Access Compliance Report

Public Rights-of-Way

(Pedestrian Signals)

Intersection ID: N/A	Main Street:	Cross Street: N/A	Location: N/A
ADA ID: 31EBA366859C	Signal Type: One Push Button-Non APS	Overall Compliance: No	Severity Score: BTN 1: N/A BTN 2: N/A No BTN: N/A
Codes/Mitigation Info/Possible Solution		Field Measurements/Component Compliance

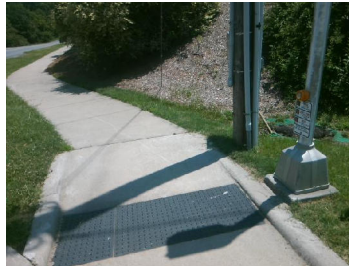
Surveyor Notes: TEXT HT 1/2

PROW/ADA: R410.6, TMUTCD 4e.08, R404.2, R406.2, R404.7.3

Possible Solutions: Replace Signal Push Button With APS Button on New Post. Remove & Replace Sign.
